**Appendix DD**  
**Response to Public Comments on the Draft FR/EIS**

Appendix DD, Response to Public Comments on the Draft FR/EIS, includes the following information:

**Figure 4-12**  
**Percent Change in Flow from Baseline in the South Platte River**  
**Below Chatfield Reservoir if Alternative 3 Were Implemented**

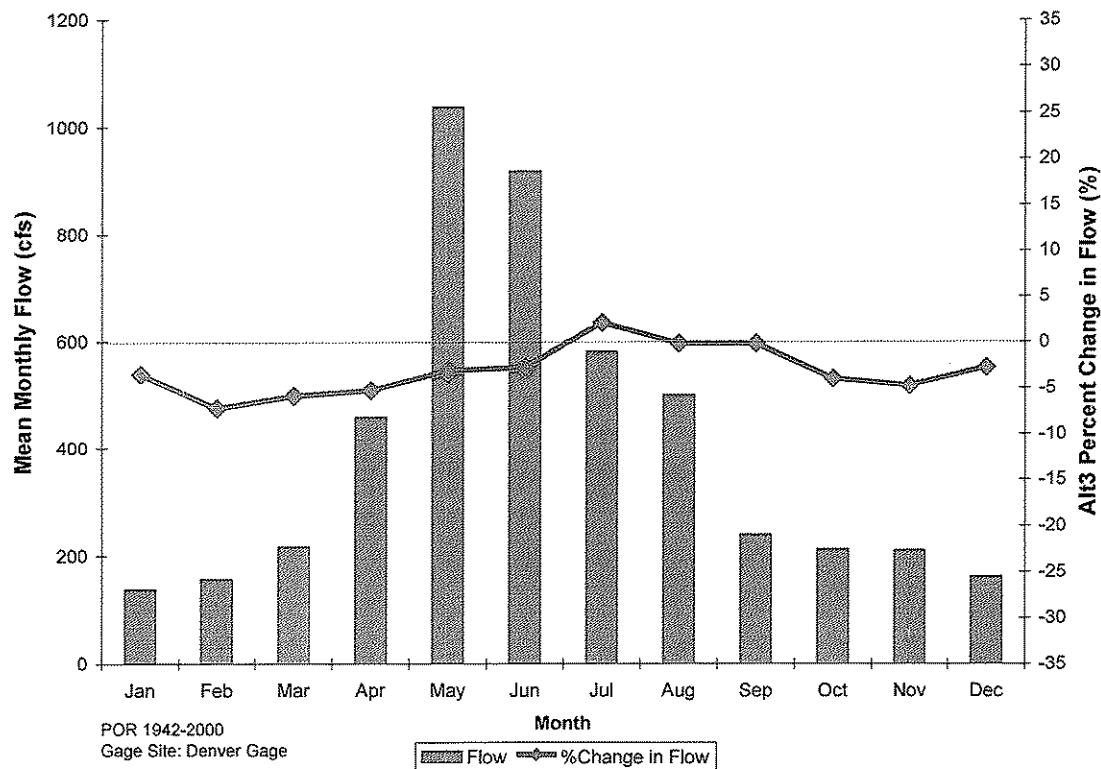
The Draft FR/EIS, however, dismissed downstream impacts to aquatic biota as “insignificant” largely, if not entirely, as a result of the analysis of *the average monthly flow data* depicted in Figure 4-12 in the Draft FR/EIS. A copy of Figure 4-12 is attached, and depicts both monthly average flows during the study period and the expected change to that monthly flow if the Tentatively Selected Plan (Alternative 3) is implemented. From this data the Corps concludes, without elaboration, that the up to 5% reduction in *average monthly* flows that will take place 9 months of the year (and nearly 10% reduction in flows in February) constitute a “minimal” change with an “insignificant” impact on aquatic biota, while the less than 5% increase that will take place in the single month of July “would have a positive effect on aquatic biota downstream of the reservoir.” Draft FR/EIS at 4-51. What is puzzling to Littleton is not just that these

The correlation between this average monthly flow data and potential harm to aquatic life in the Park becomes even more tenuous when it is considered that this data comes from measurements taken at the Denver Gauge, which is located approximately 15 miles downstream from Chatfield Reservoir. Several tributaries flow into the South Platte River downstream of the Park and upstream of the Denver Gauge, including significant tributaries such as Bear Creek and Cherry Creek, that obscure any meaningful connection between the data presented in Figure 4-12 and environmental impacts in the Park.

The DEIS predicts reductions in streamflow below Chatfield Reservoir due to the Reallocation in the fall and winter months (Figure 4-12). Currently flows can and do fall below acceptable levels during these periods, and the South Platte River just below the reservoir is frequently dried up. We believe that if further flow reductions occur it will result in additional impacts including but not limited to loss of aquatic life (fish and invertebrate) and potential negative water quality impacts that could reach downstream until additional untreated water is added to the river channel and reduced recreational opportunity. We agree that some of the sportfish found downstream of the reservoir are more typically found in standing water but want to also emphasize that rainbow and brown trout are year round residents in streams with more consistent stream flows, species such as smallmouth bass and walleye could also become year round residents. The reach of river extending from Chatfield Dam to Confluence Park is a very
